NOTICE OF ADDENDUM

ADDENDUM NO. 2

CITY OF MADISON
NAKOOSA TRAIL FLEET/FIRE/RADIO SHOP FACILITY

AS-002

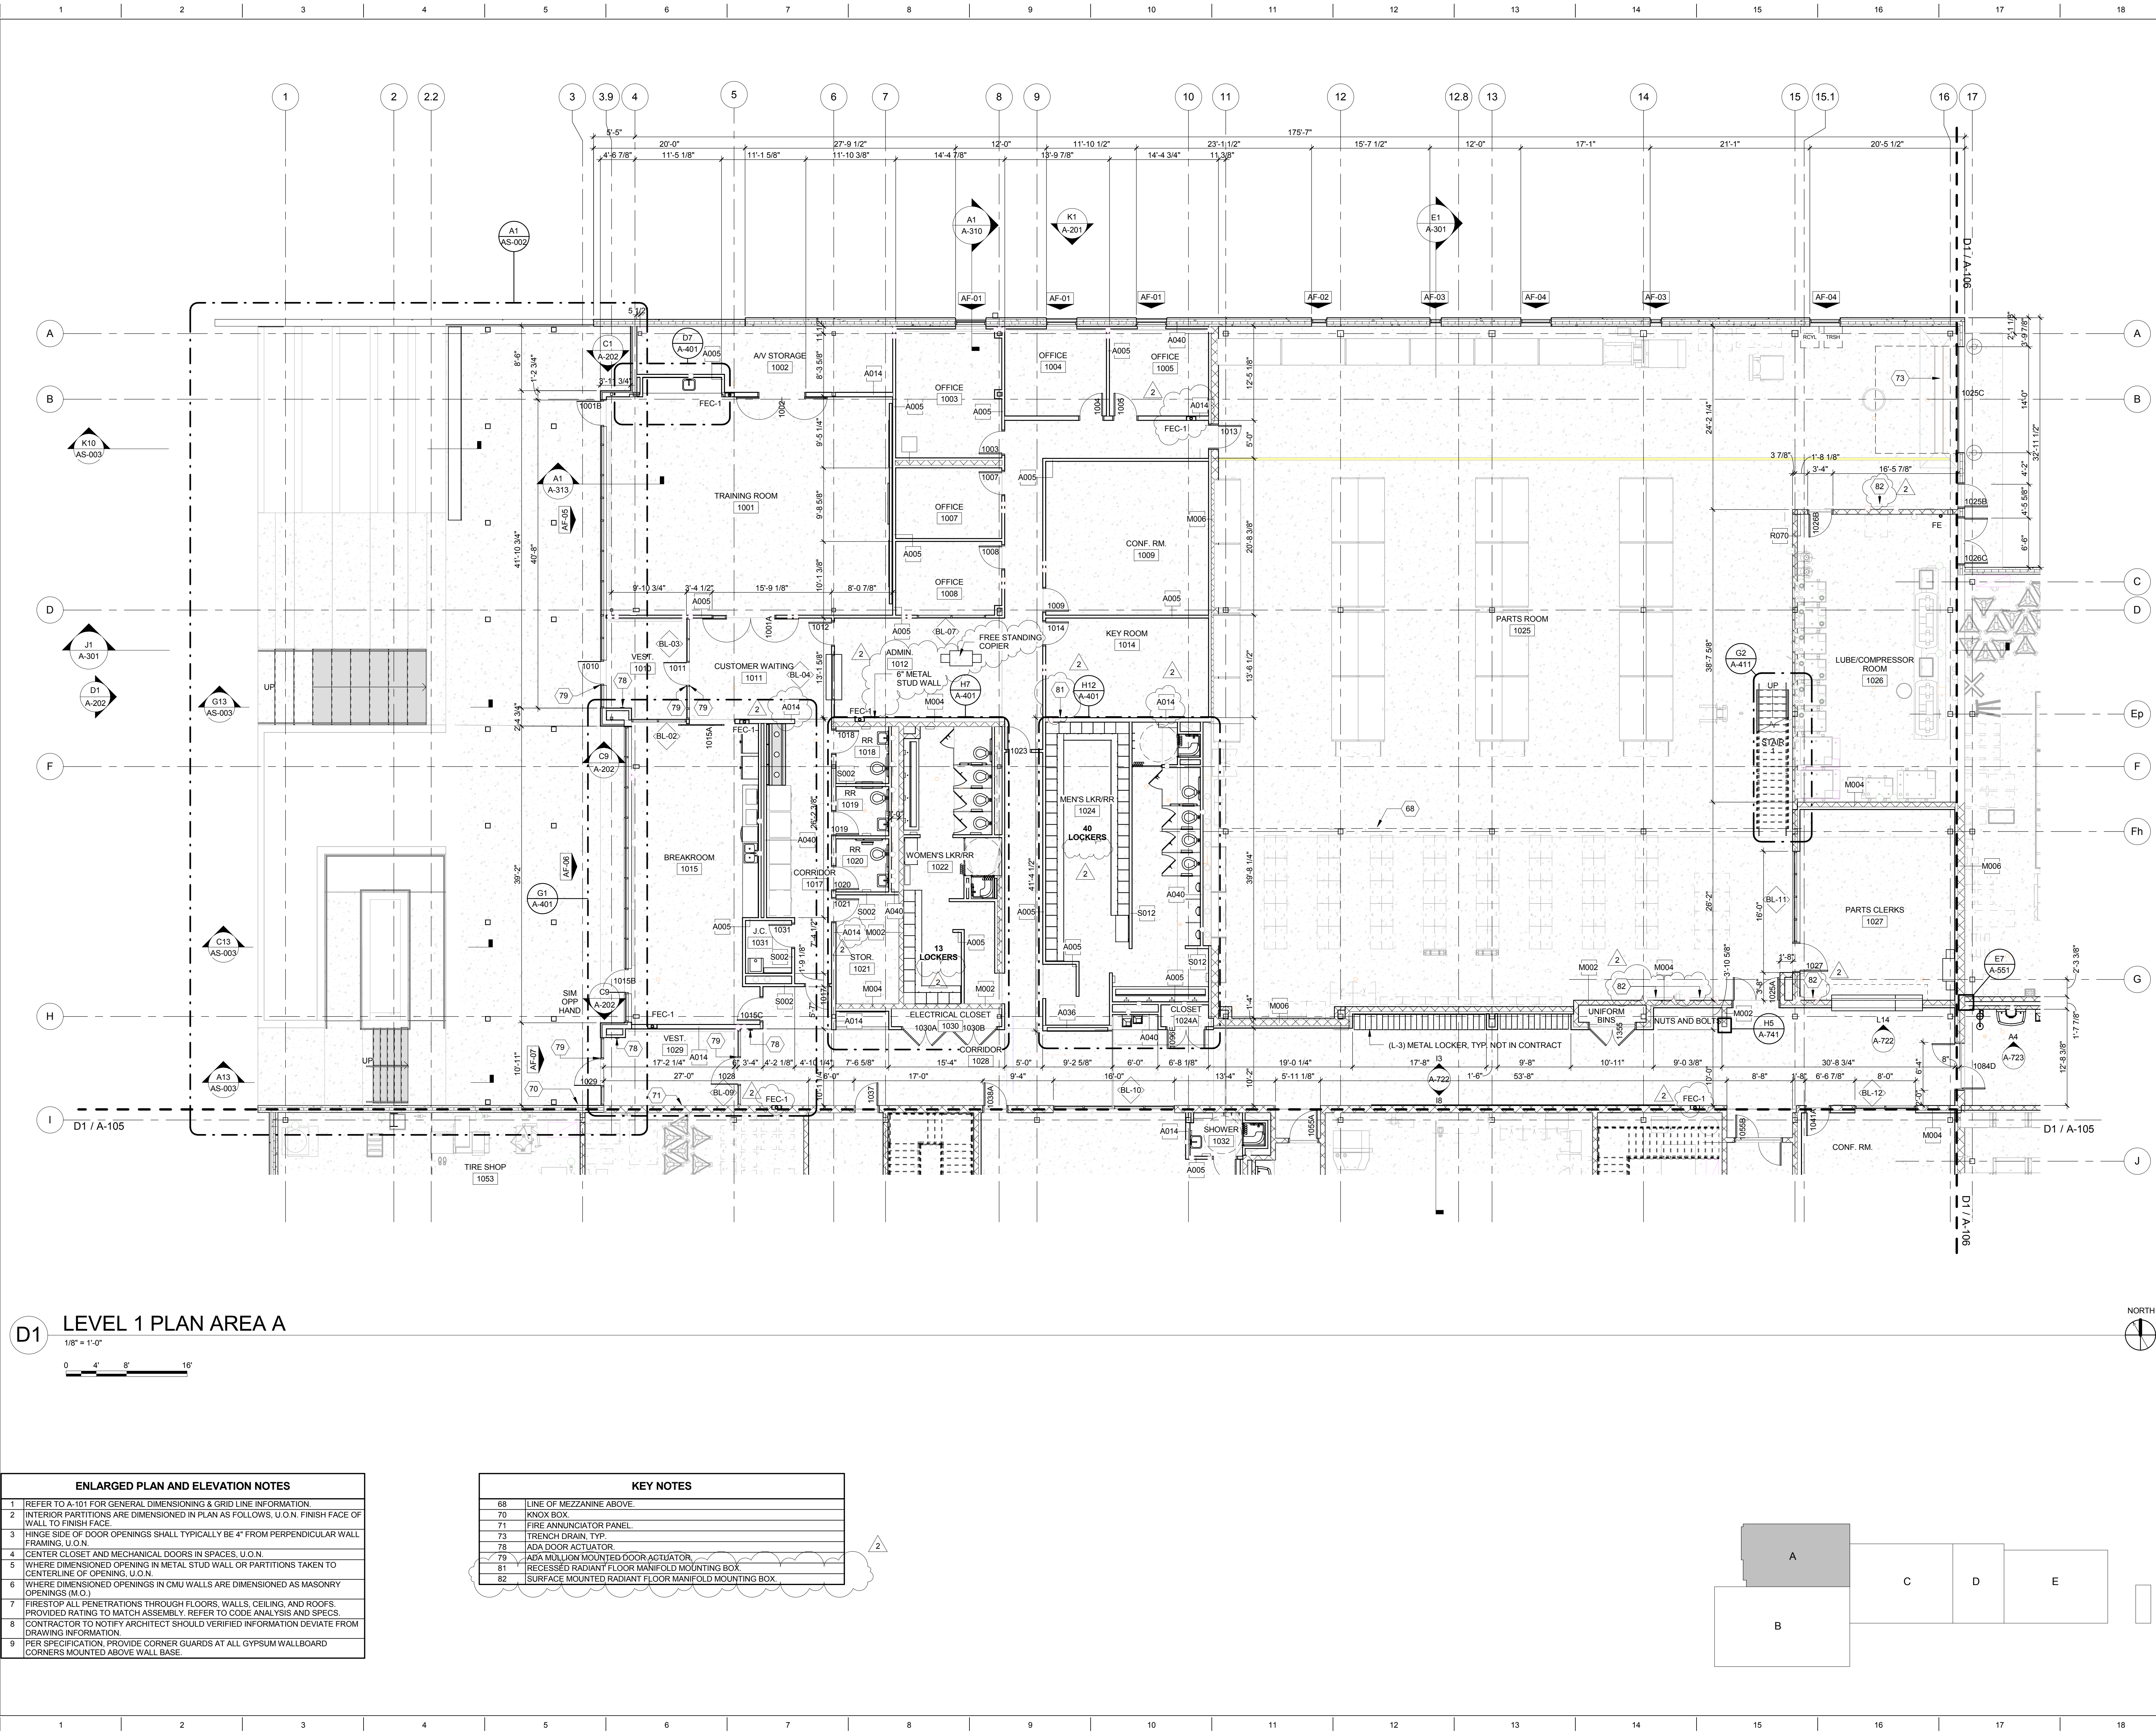
- K. **MODIFIED** AS-002 002 to add dimension for the length of the perforated metal screen in drawing A1
- L. **MODIFIED** A-104 LEVEL 1 FLOOR PLAN AREA A to:

A-106

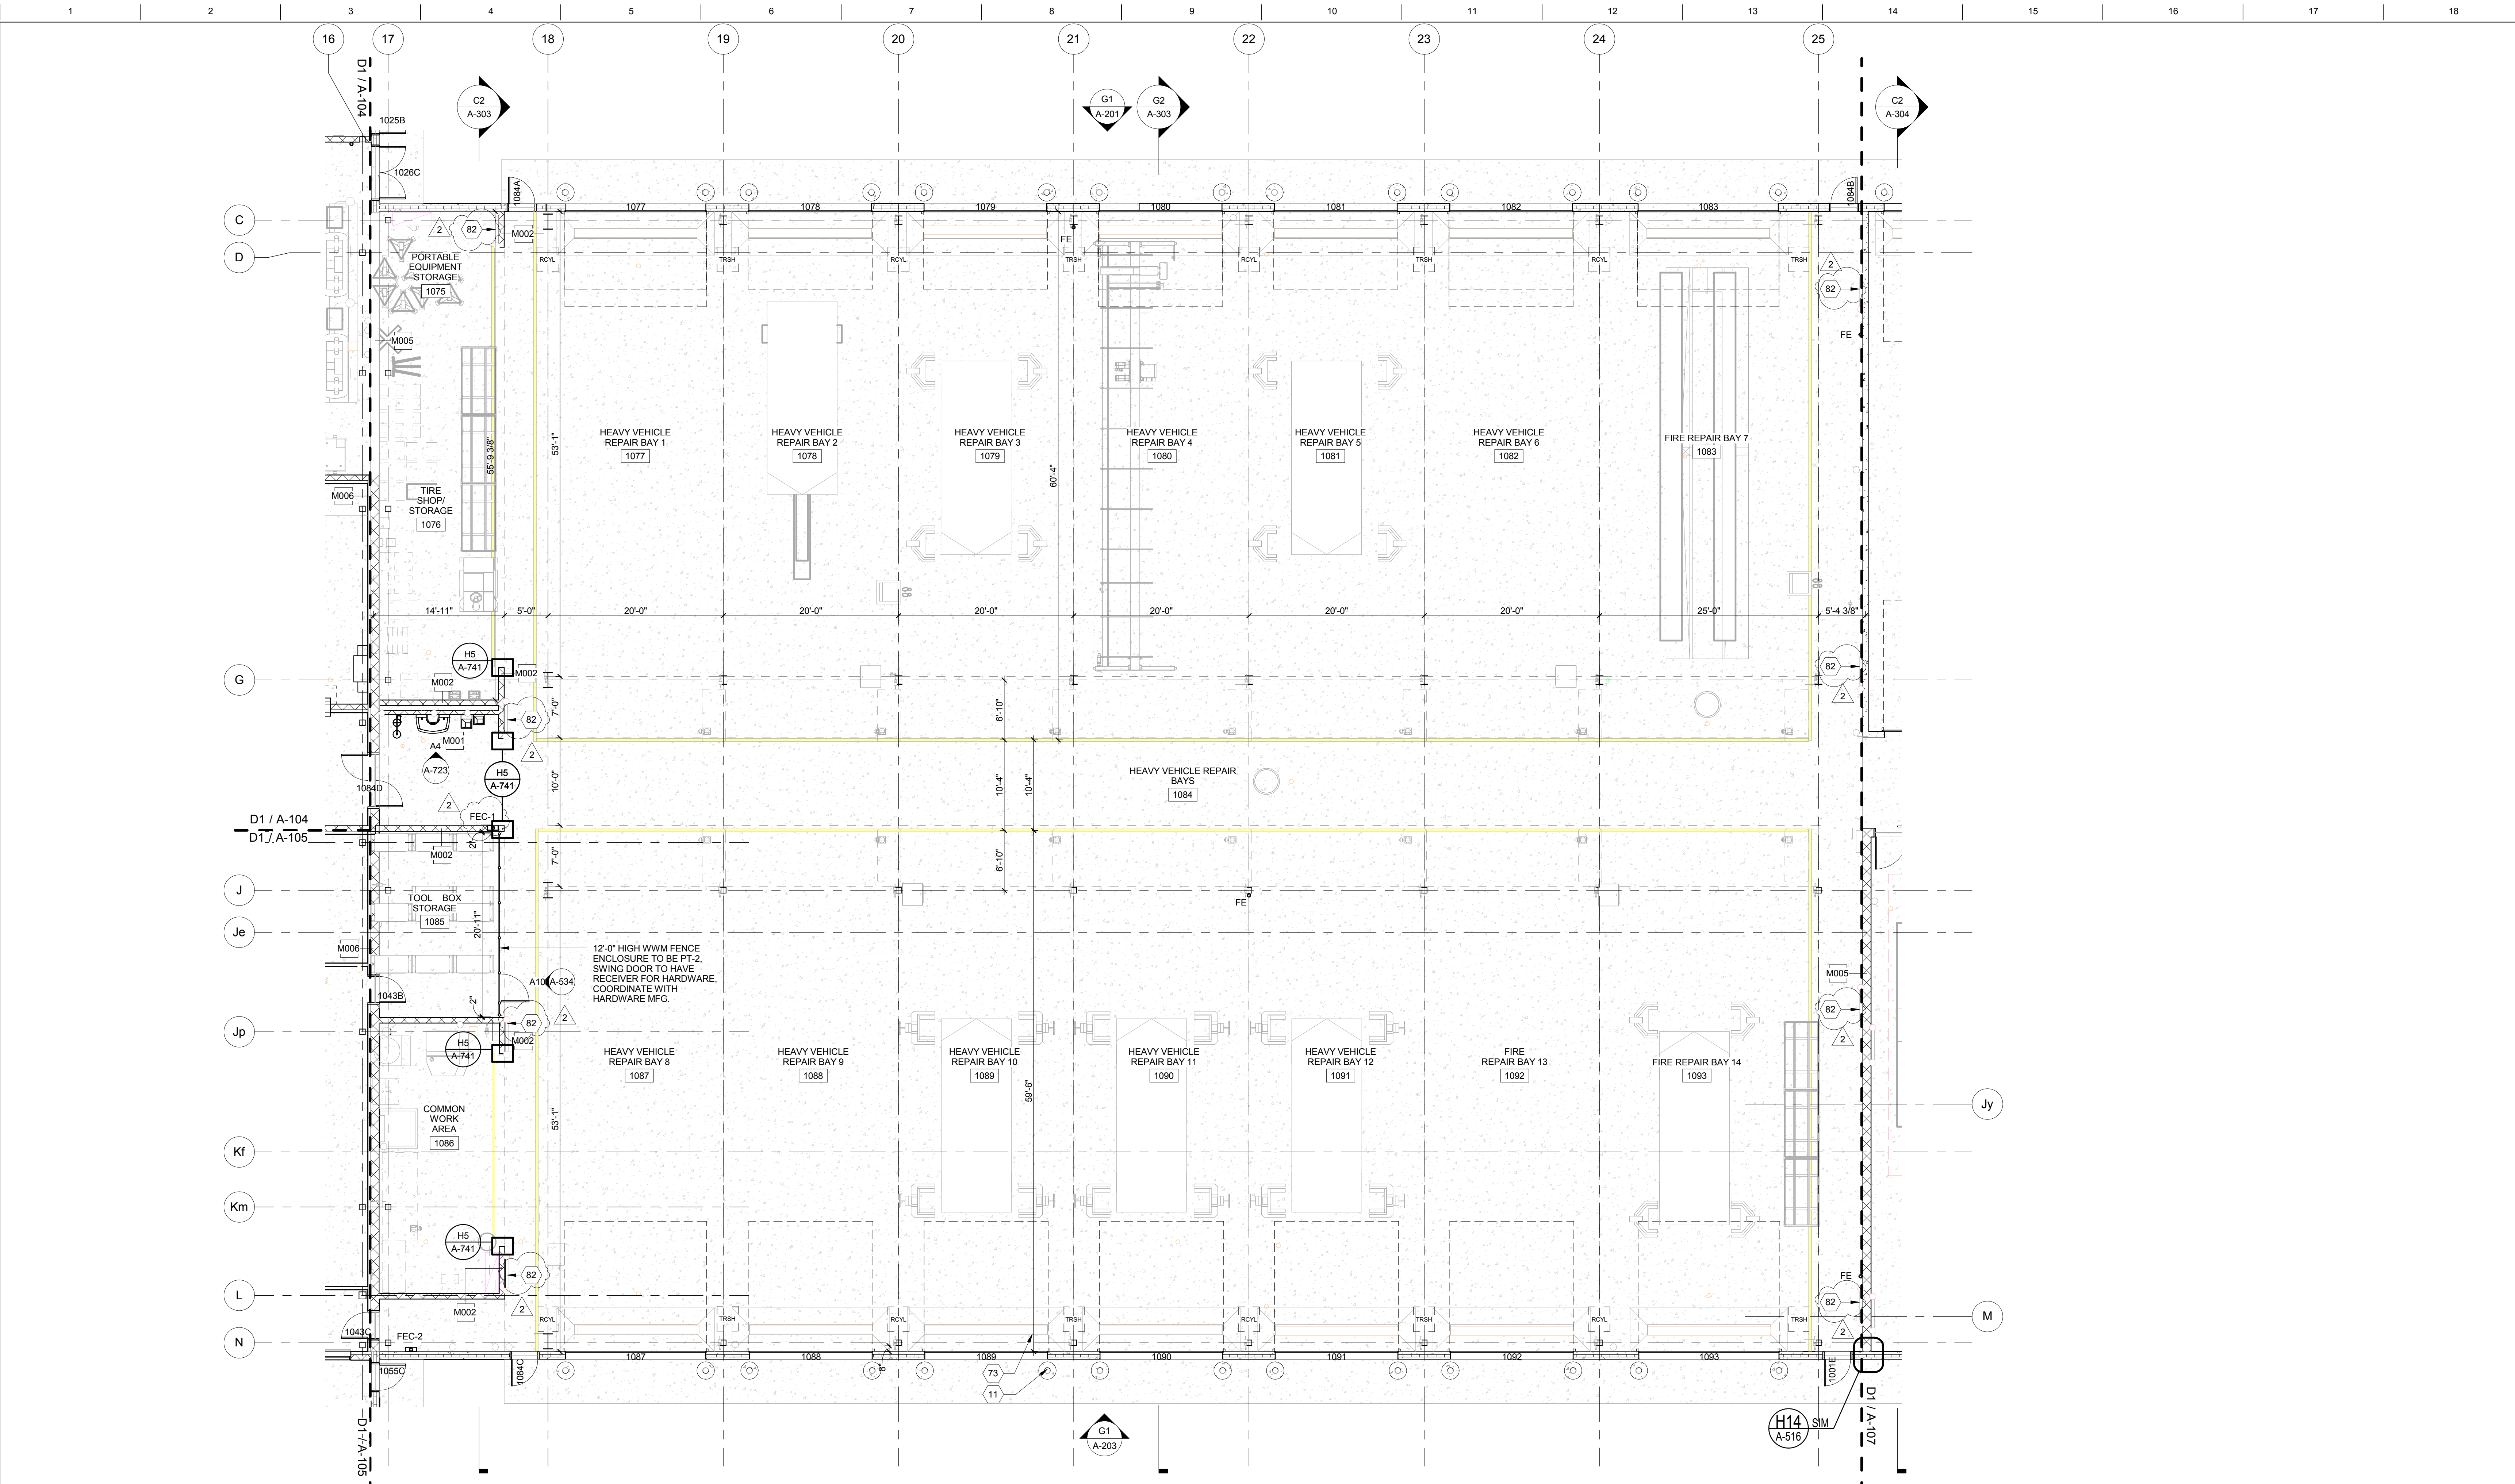
- N. **MODIFIED** A-106 LEVEL 1 FLOOR PLAN C to add key note for radiant flooring manifold mounting box location and to revised fire extinguisher from wall mount to comply with ADA requirements

A-107

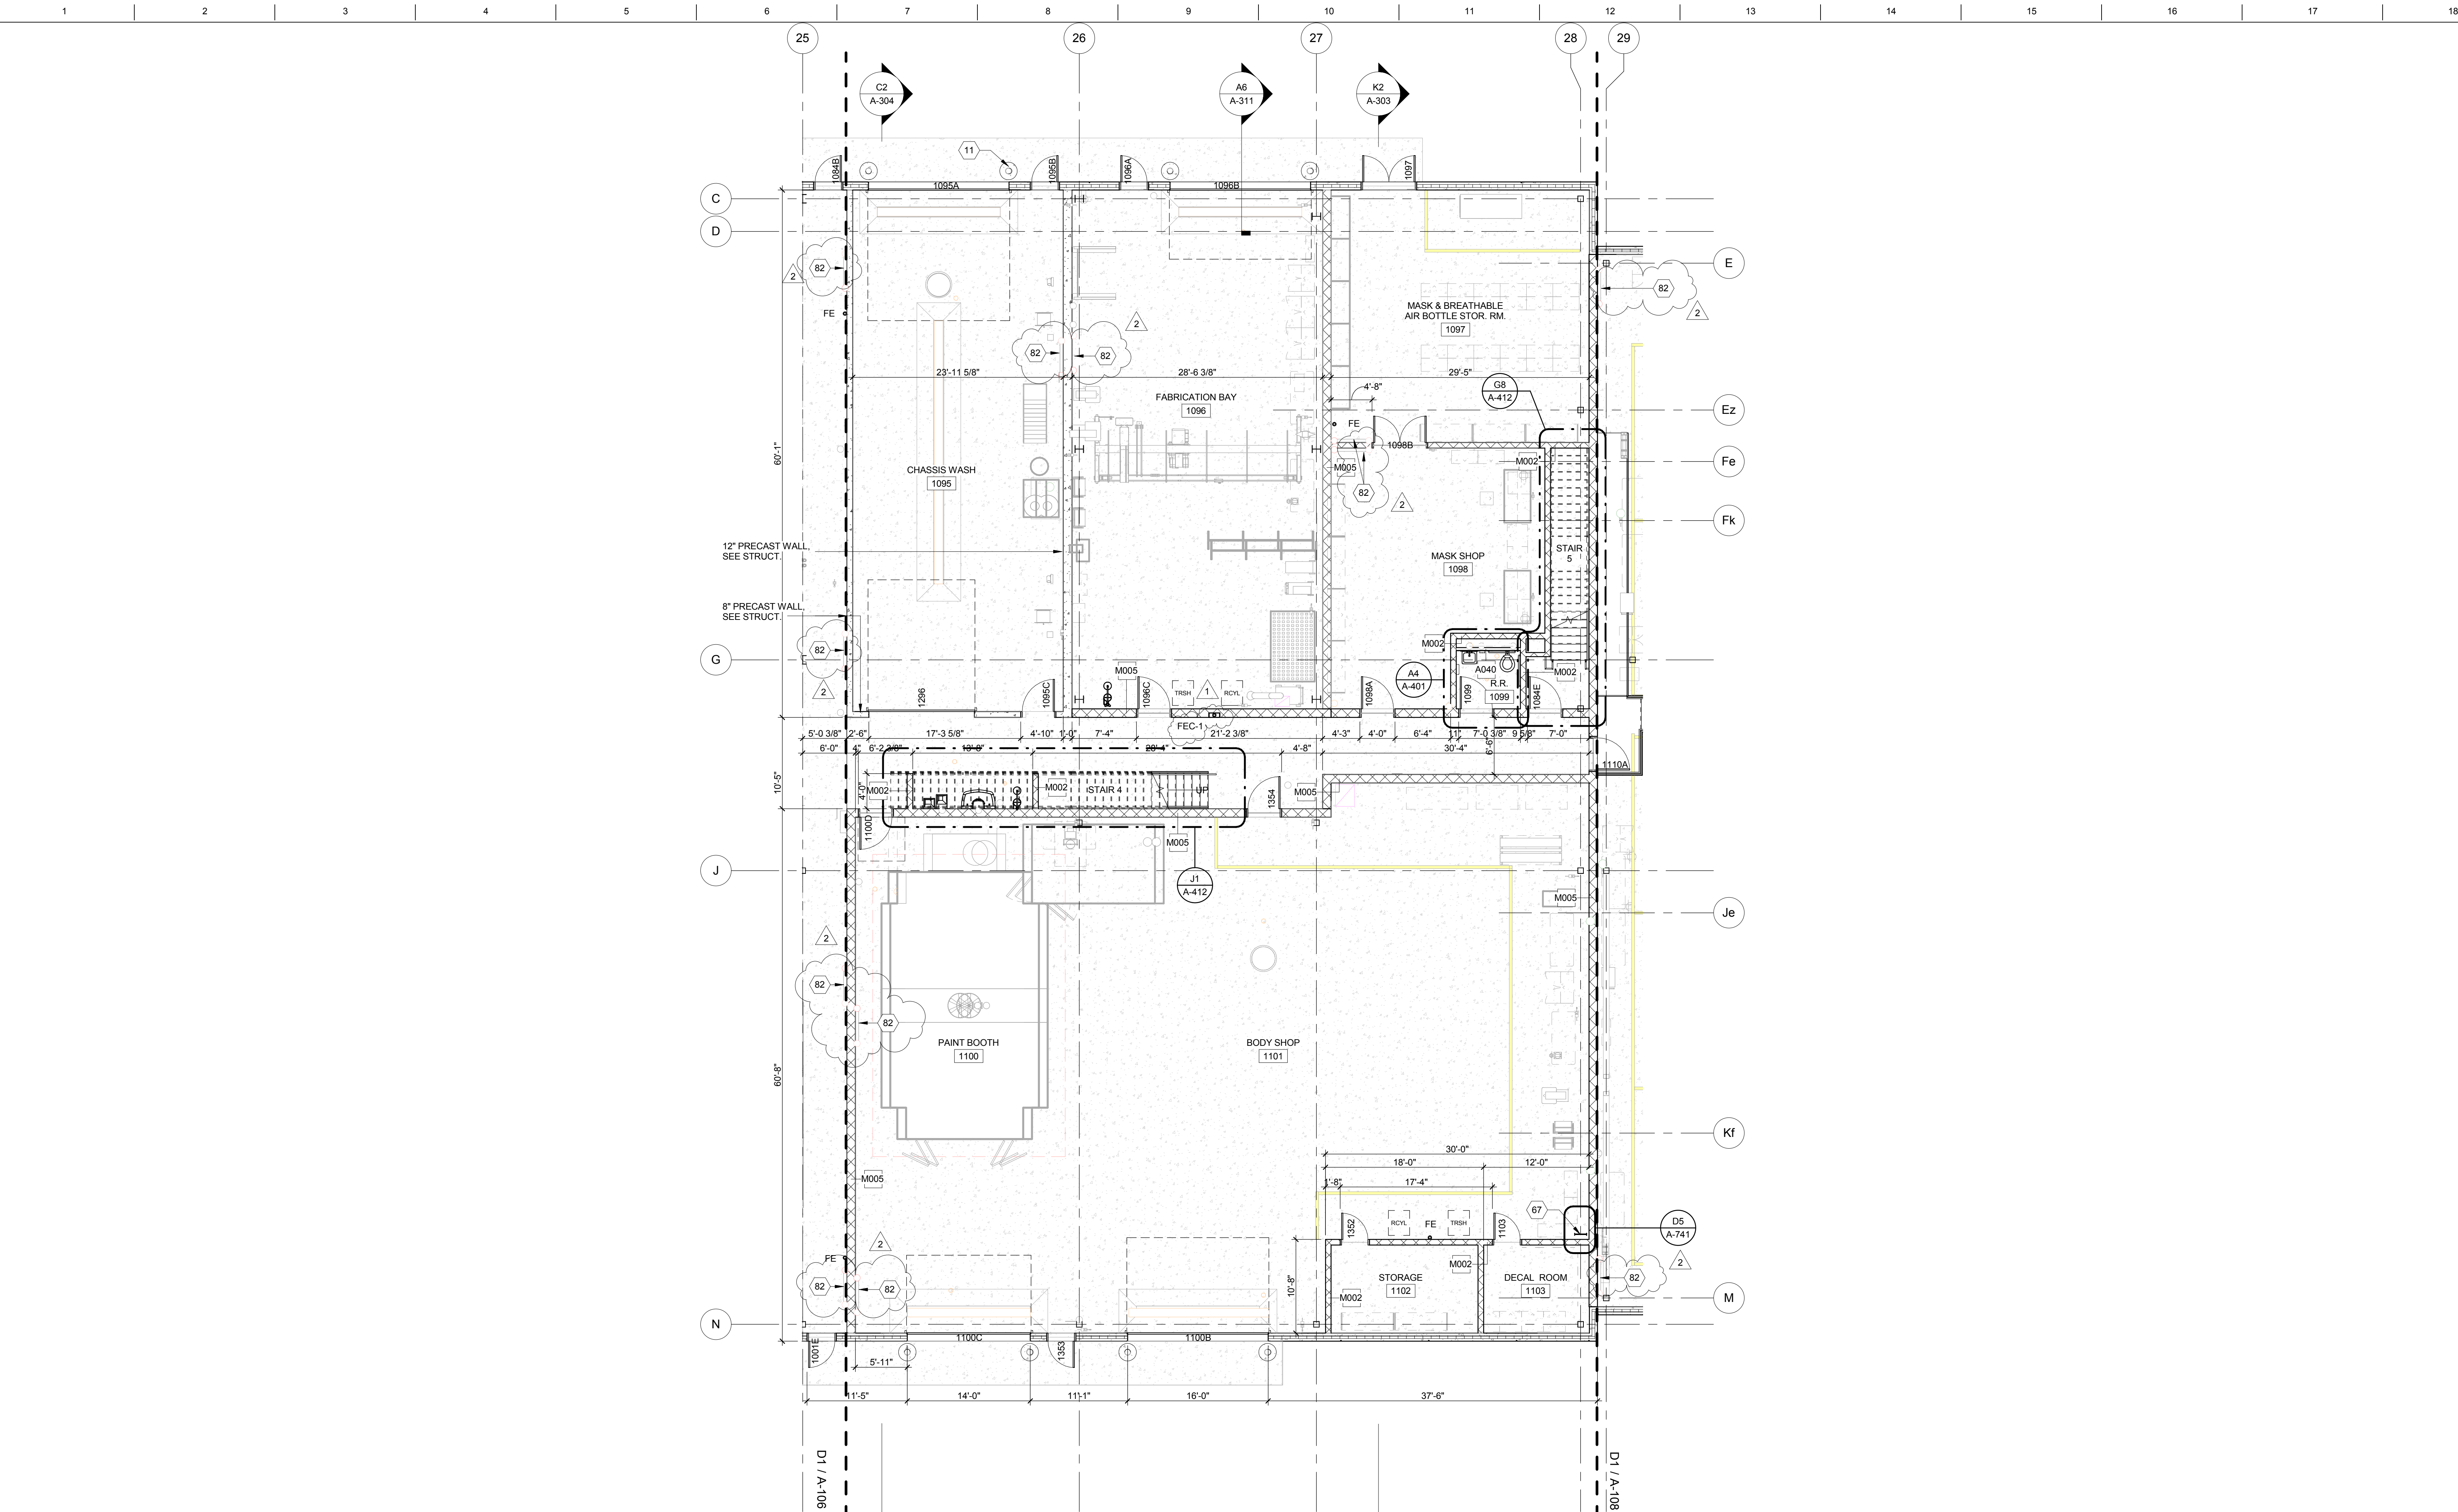
- O. **MODIFIED** A-107 LEVEL FLOOR PLAN D to add key note for radiant flooring manifold mounting box location and to revised fire extinguisher from wall mount to comply with ADA requirements
